AIRCRAFT AND MAINTENANCE PARTS

NORTH AMERICAN—REWORK OF LANDING-GEAR FAIRING DOOR ACTUATING
MECHANISM—P-51D, P-51K, F-6D, AND F-6K

This Technical Order replaces T. O. No. 01-60JE-11, dated 4 September 1944, which directed installation of cable fair-lead.

Figure 1 - Existing Cable Installation

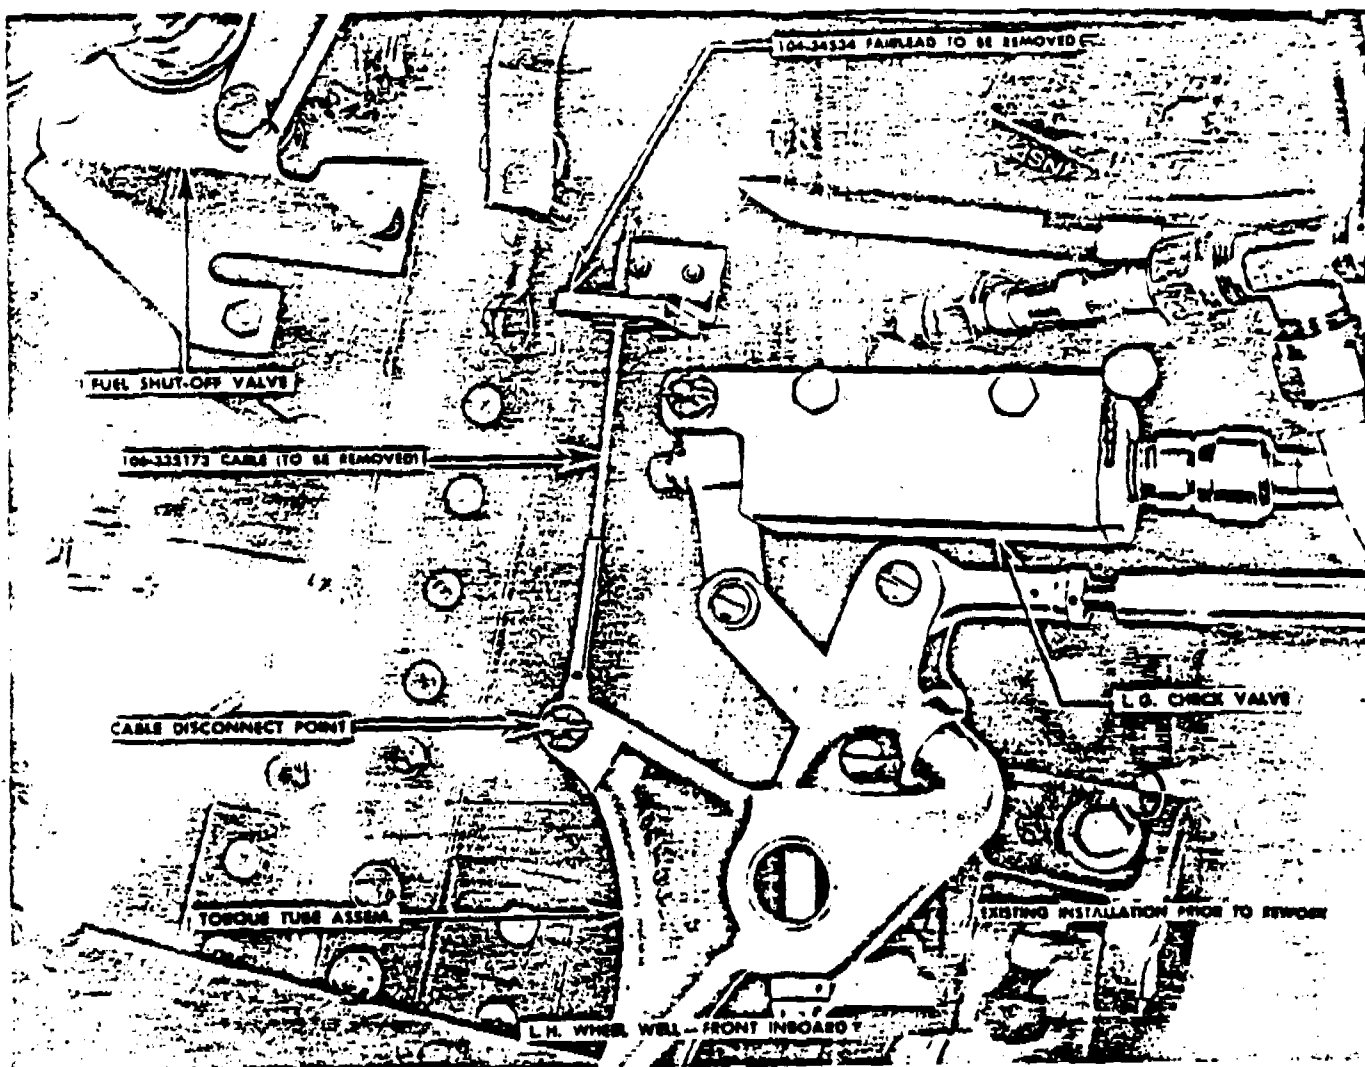
d. In the left wheel well disconnect the cable, part No. 106-335173 (or 109-335173), which is attached to

the torque tube assembly and pull through the center rib into the right wheel well. (See figure 1.)

g. Remove the fair-lead, part No. 104-34534 (with 109-33367 clip attached), on station O (center) rib adjacent to the landing-gear check valve, by drilling out the two attaching rivets. Some airplanes will have this fair-lead attached with screws. (See figure 1.)

Figure 2 - Replacement of Hydraulic Lines

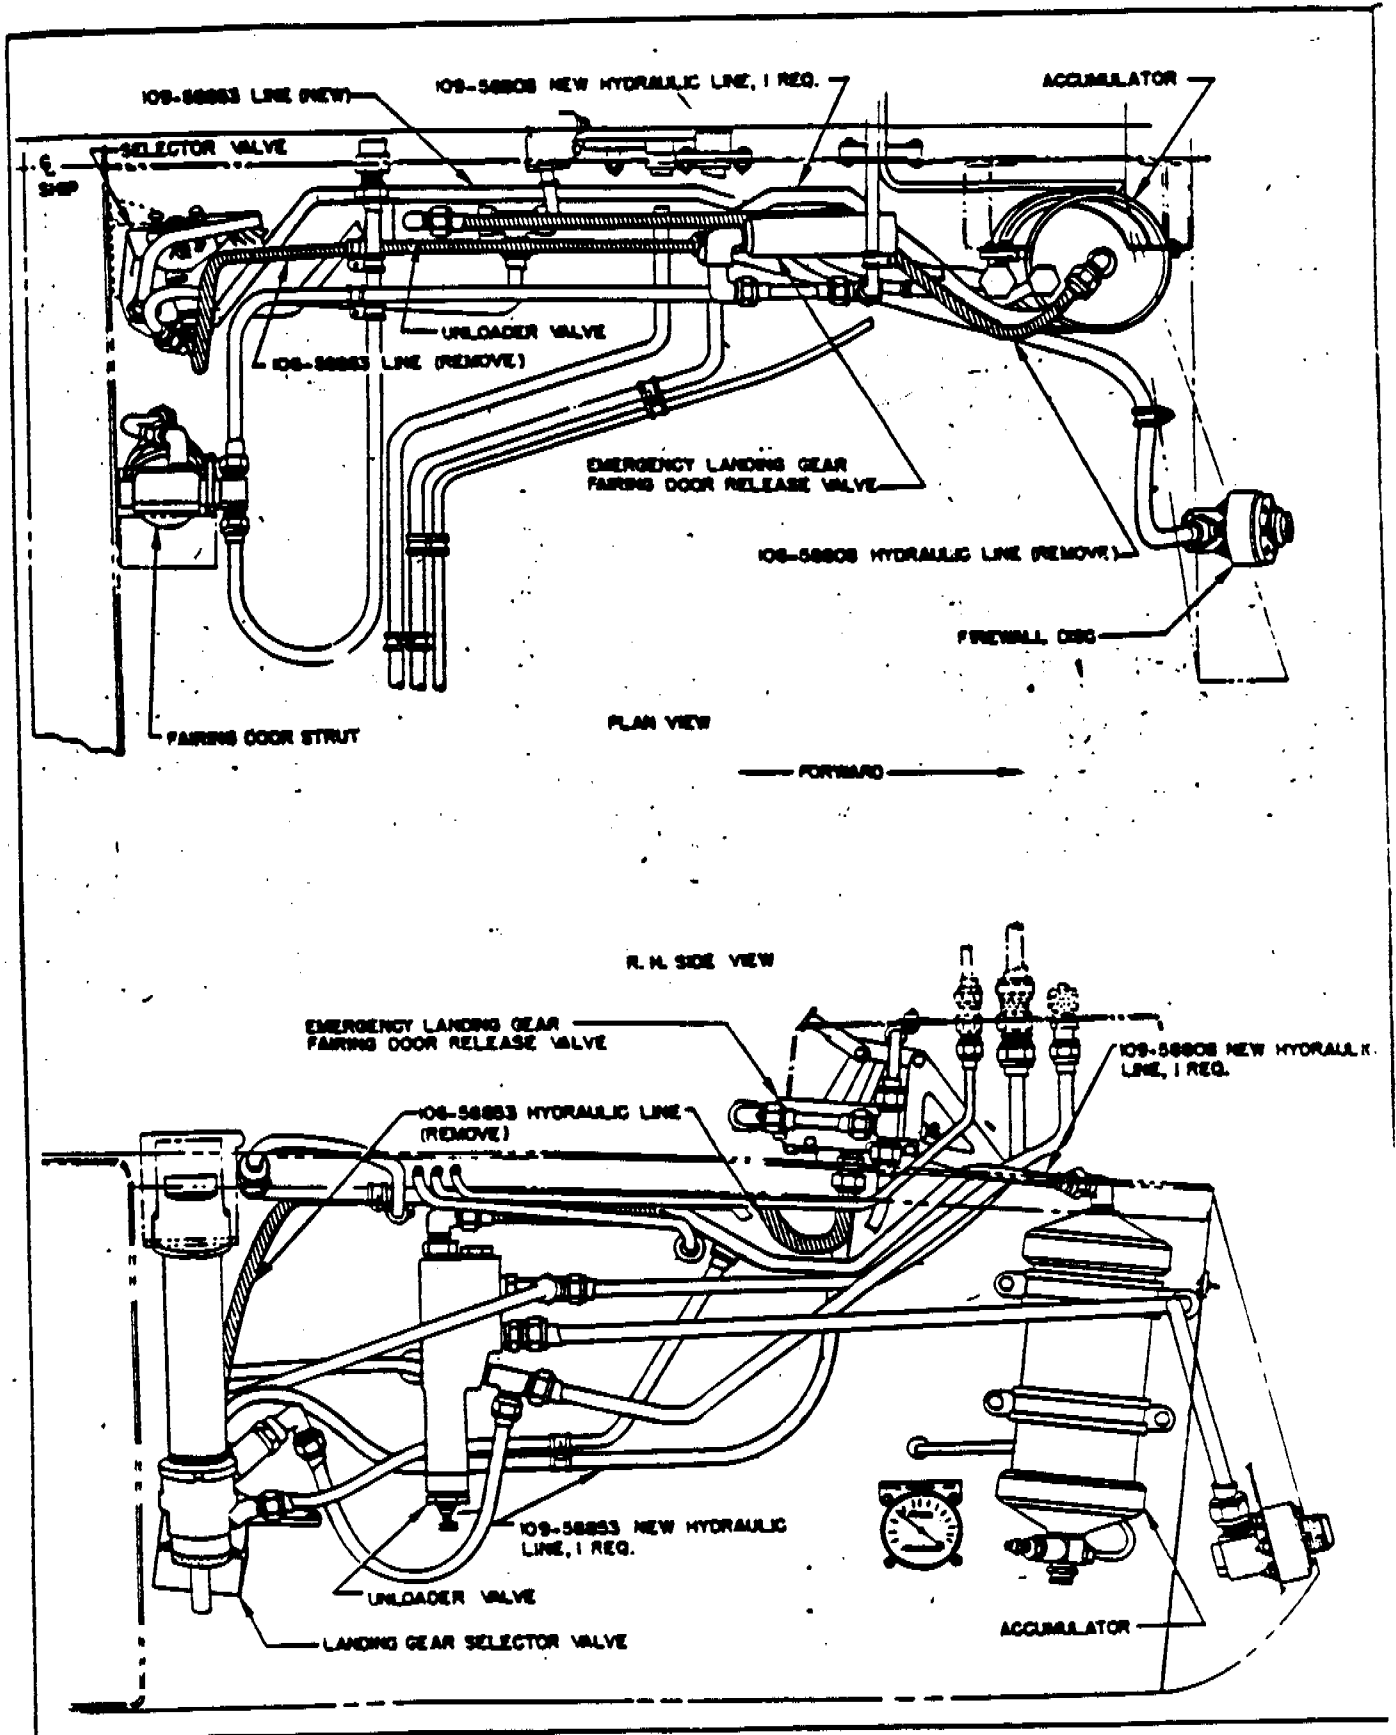
e. Two hydraulic lines in the right wheel well are to be removed and replaced with new lines to provide clearance for the new bell crank. Disconnect and remove the lines as follows:

(1) Remove the line, part No. 106-58808, routed from the top of the hydraulic accumulator to top of unloader valve. (See figure 2.)

(2) Remove the line, part No. 106-58853, routed from the top port of the selector valve to the bottom port of the fairing door emergency release valve.

(2) Install the line, part No. 109-58808, by routing from the top of the hydraulic accumulator to the top of the unloader valve. (See figure 2.)

(3) Install the line, part No. 109-58853, by routing from the top port of the selector valve to the bottom port of the emergency fairing door release valve.

Figure 4 - Cut-out in Center Rib

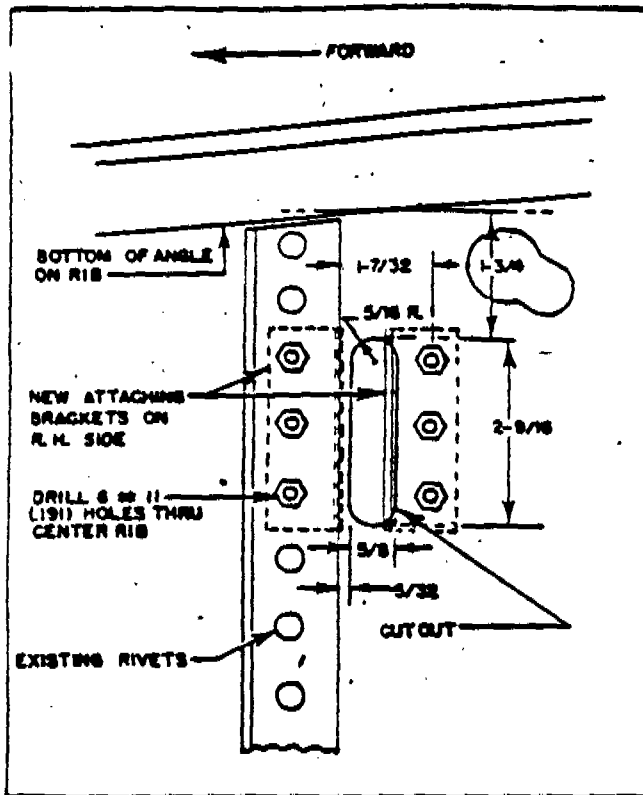
l. Make the cut-out in the center rib, just aft of the reinforcing angle in accordance with the dimensions shown in figure 4.

Figure 5 - New Cable and Rod Installation Left Wheel Well

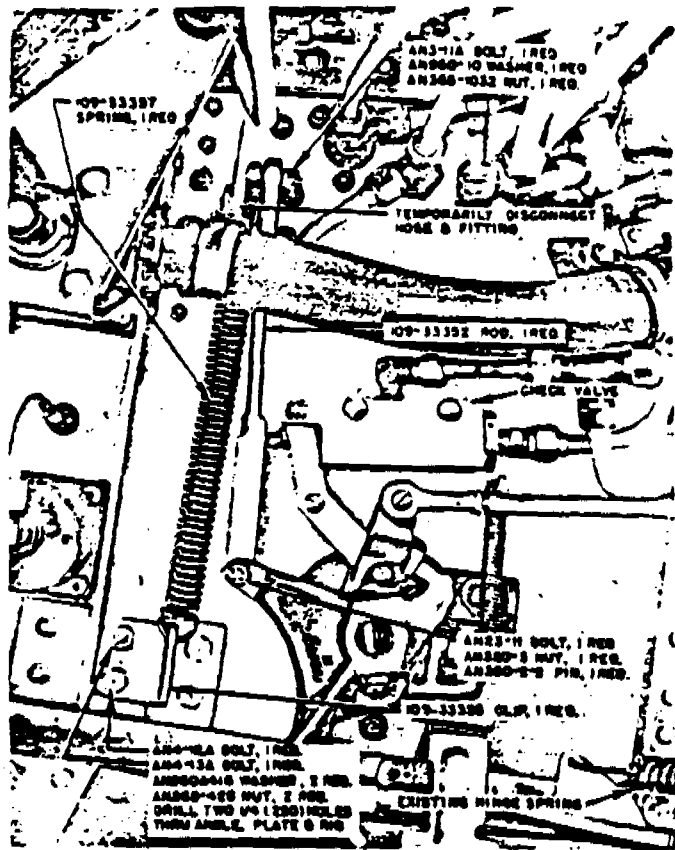
l. The bell crank, part No. 109-33353, and attaching brackets, are to be installed on the right side of center rib, adjacent to the new cut-out as follows:

(1) Install the forward bracket, part No. 109-33351, over the angle and secure with the attaching parts as shown in figure 5.

(2) Install the bell crank, part No. 109-33353, and aft bracket, part No. 109-33354, by securing to the forward bracket as shown in figure 5.

(3) Using the aft bracket as a template, drill three No. 11 (.191-inch) holes through the rib.

(4) Secure the aft bracket with the attaching parts as shown in figure 5.

(f) Install the cable, part No. 109-33556, by connecting it to the bell crank on the center rib with the attaching parts as shown in figure 5.

Figure 6 - Cables and Attaching Parts - Right Wheel Well

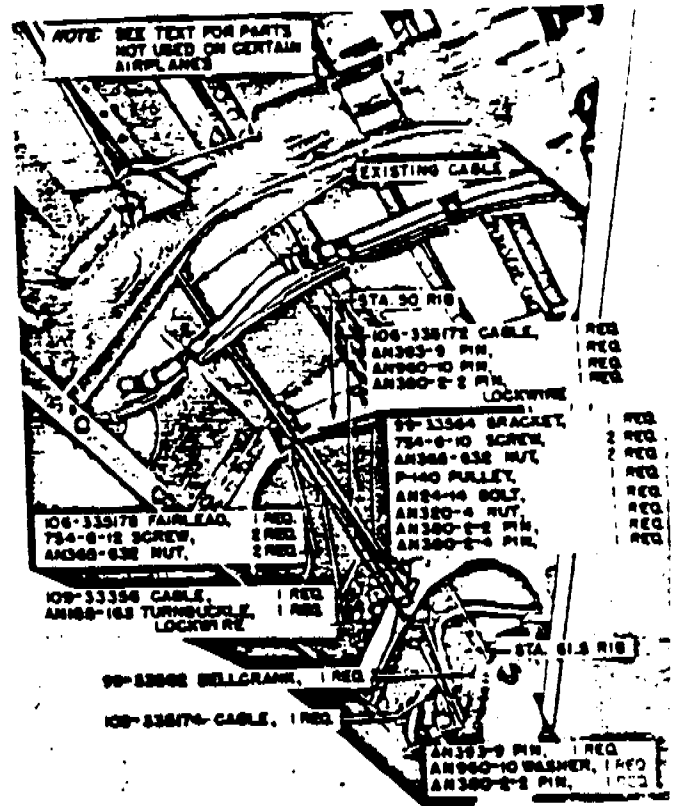
(a) Remove the cable, part No. 106-335173, routed from the torque tube arm to the turnbuckle just outboard of station 50 rib by disconnecting at the turnbuckle. (See figure 6.)

out the holes in the rib and install the new bracket (same part number). Attach it to the rib with the screws as shown in figure 6. Remove the pulley and attaching parts from old bracket and install them on the new bracket with the new additional pulley and attaching parts as shown in figure 6.

(e) Remove the fair-lead, part No. 106-335178, from station 50 rib by drilling out the attaching rivets. Install the new fair-lead (same part number) and secure it to the rib with the attaching parts as shown in figure 6.

(g) Install the cable, part No. 109-335174, by routing it from the bell crank on the landing-gear strut to the turnbuckle connection with the inboard cable, part No. 109-33356. Route cable through the new fair-lead and pulley bracket and install the new turnbuckle and attaching parts as shown in figure 6.

wheel well to the turnbuckle in right wheel well just outboard of station 50 rib. Disconnect cable at the turnbuckle and remove the turnbuckle. (See figure 6.)

(c) Install the new turnbuckle, part No. AN155-168, by securing it to the existing cable routed from the bell crank on the landing-gear strut. (See figure 6.)

(d) Install the cable, part No. 109-33356. Route from the new turnbuckle to the bell crank on the center rib. Secure the cable to the turnbuckle and to the bell crank with the attaching parts as shown in figure 6.

(a) Remove the cable, part No. 109-335173, which is routed from the torque tube arm in the left wheel well to the turnbuckle in the right wheel well just outboard of station 50 rib. Disconnect cable at turnbuckle and remove the turnbuckle. (See figure 6.)

(c) Install the new turnbuckle, part No. AN155-168, by securing to the existing cable routed from the bell crank on the strut. (See figure 6.)

(d) Install the cable, part No. 109-33356, routing it from the new turnbuckle to the bell crank on the center rib. Secure the cable to the turnbuckle and to the bell crank with the attaching parts as shown in figures 5 and 6.

Figure 7 - Replacement of Yokes and Rollers

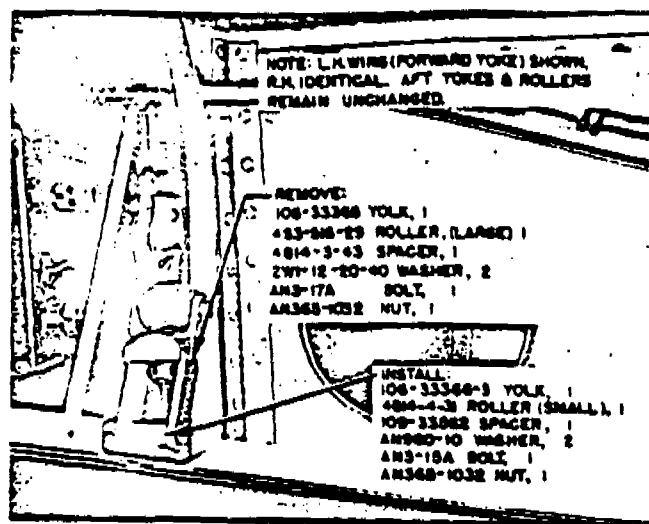
NOTE The replacement of the forward yokes and rollers on the preceding airplanes is necessary to provide clearance between the yoke and the door skin and preclude the possibility of malfunctioning of the door locks. The aft rollers and yokes which are the same as the forward ones will not require rework. Refer to figure 7 in conjunction with the following instructions which apply to both left and right wheel wells.

(a) Locate the forward door lock yoke at sta 83.5 rib in the wing leading edge, just outboard of gun camera. (See figure 7.)

(b) Remove the complete yoke and roller assembly by detaching the vertical bolt which secures unit to the upper portion of the latch and spring assembly. Save the washers and nut from the vertical. Remove the nut which secures the smaller horizontal roller for installation on the new roller assembly.

(c) As shown in figure 7, assemble a new yoke and roller assembly consisting of a new yoke, spacer, roller, bolt, washers, and the nut removed from the horizontal roller.

(d) Install the new unit by securing it to the upper portion of the latch and spring assembly with the nut and washers removed in paragraph 2.g.(4)(b).

Figure 8 - Adjustment of Cable and Rod

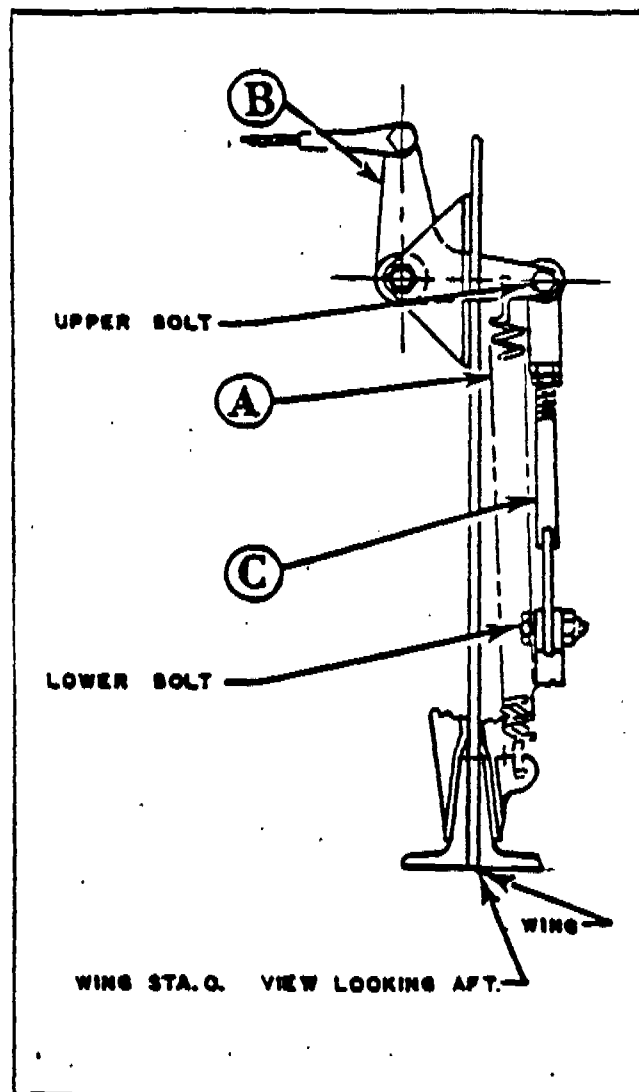
3. ADJUSTMENT OF REWORKED MECHANISM. - The adjustment of the new fairing door actuating cable and rod is to be accomplished with reference to figures 3 and 8 as follows:

(2) Remove both hinge springs, and spring "A" on bell crank. (See figure 8.)

(3) Adjust cable so vertical arm of bell crank will travel an equal distance both sides of vertical with the travel of the gear.

(4) With gear handle to torque tube linkage correctly adjusted, have gear in "DOWN" position and landing-gear handle in "UP" position. Connect spring "A." Place upper bolt in rod "C." Adjust rod "C" so that when lower bolt is installed it can be inserted without difficulty. Actuate hinge rod "C" so as to fully retract door locks while installing lower bolt.

Figure 9 - Adjustment of Fairing Door Rollers

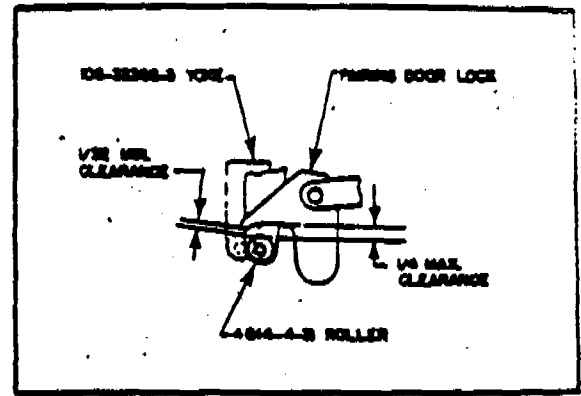
4. The yokes and rollers are to be adjusted with adherence to the following and reference to figure 9. There should be 1/32 to 1/16 inch between the tip of the hook and the roller when the roller is actuated with the fairing doors retracted under hydraulic pressure in the gear up position. This adjustment may be obtained by changing washers on the vertically positioned bolt which secures the upper portion of the yoke. Transpose the washers from the top to the bottom of the yoke or vice versa as required. If all washers are exhausted from above the yoke, then the 1/16-inch dimension may be increased, but only until a dimen-

sion of 1/4 inch is reached from the lower face of the hook to the roller.
